**QUALITY ASSURANCE -- NON-CONFORMANCE REPORT**

**Location:** Changxing Island, Shanghai, P.R. China**Report No:** NCR-000303**Prime Contractor:** American Bridge/Fluor Enterprises, a JV**Date:** 10-Jun-2009**Submitting Contractor:** Zhenhua Port Machinery Company, Ltd (ZPMC), Changxing Island**NCR #:** ZPMC-0277**Type of problem:****Welding****Concrete****Other****Welding****Curing****Procedural****Bridge No:** 34-0006**Joint fit-up****Coating****Other****Component:** OBG Segments 4AE/4BE**Procedural****Procedural****Description:**

**Reference Description:** Heat Straightening Without the Engineer's Approval, Longitudinal Diaphragms at 4AE/4BE Segment Splice

**Job Name:** SAS Superstructure

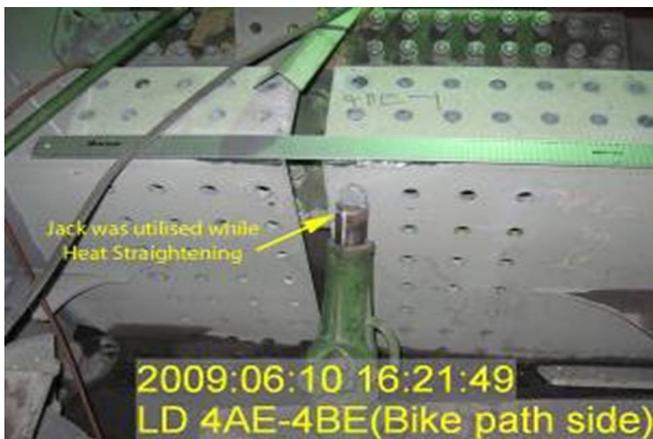
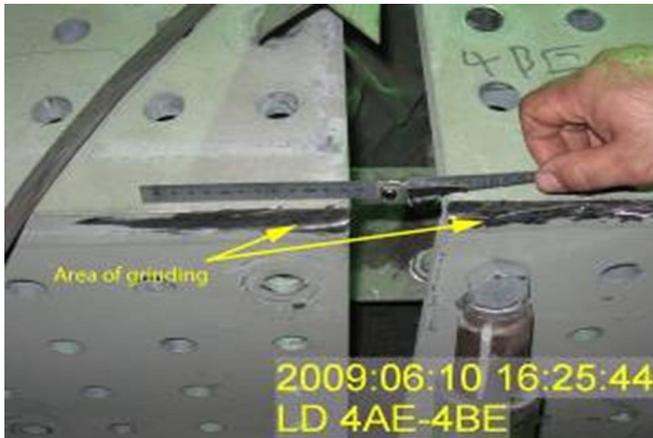
1. The misalignment between Longitudinal Diaphragms LD008-001 (Segment 4AE) and LD018-001 (Segment 4BE) was measured as 12mm. This LD splice was subjected to heat straightening without the Engineer's approval.
2. The heat straightening report utilized at this location was not applicable to the specific work being performed.
3. A mechanical jack was utilized during this process and mechanical jacking was not specified for use on the heat straightening report.
4. Heat straightening was performed without the presence of ZPMC CWI/QC.
5. The base metal edges of the flanges were reduced by grinding to minimize the offset.

AWS D1.5 2002 Section 3.7.3: "Members distorted by welding shall be straightened by mechanical means or by carefully supervised application of a limited amount of localized heat as approved by the Engineer."

The proposed resolution is acceptable. The heat straightening record is included, and the weld in question has been accepted by VT and MT as shown in the attached documents. The Department concurs that Non-Conformance ZPMC-0277 is closed.

Heat Straightening Record(HSR1)

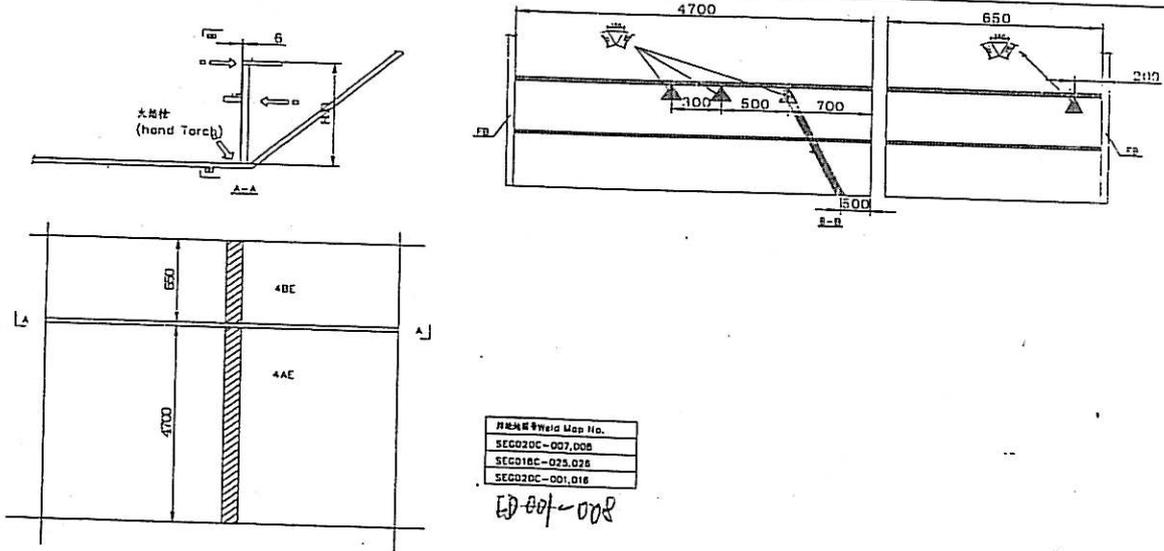
Cause原因: Welding distortion 焊接变形  
 Type of Defect缺陷类型: Welding distortion 焊接变形  
 Inspection Method检查方法: Visual 目检

注: 最大变形量约6mm, 最大宽度20~40mm.  
 NOTE: the max deformation is about 6mm, the width is 20~40mm.

缺陷去除方法(Defect Removal Method): Flame Straightening by oxygen acetylene  
 后续NDE(Post-Removal NDE): After finishing heat straightening, the weld of the heat area shall perform NDT according to the approved shop drawing  
 纠正措施(Corrective Action(s)): Control current, voltage and weld speed according to relevant WPS. If necessary anti-deformation or hold down device can be added.  
 实施次数(Number of application): 1~3  
 最高温度(Maximum temperature): <650°C
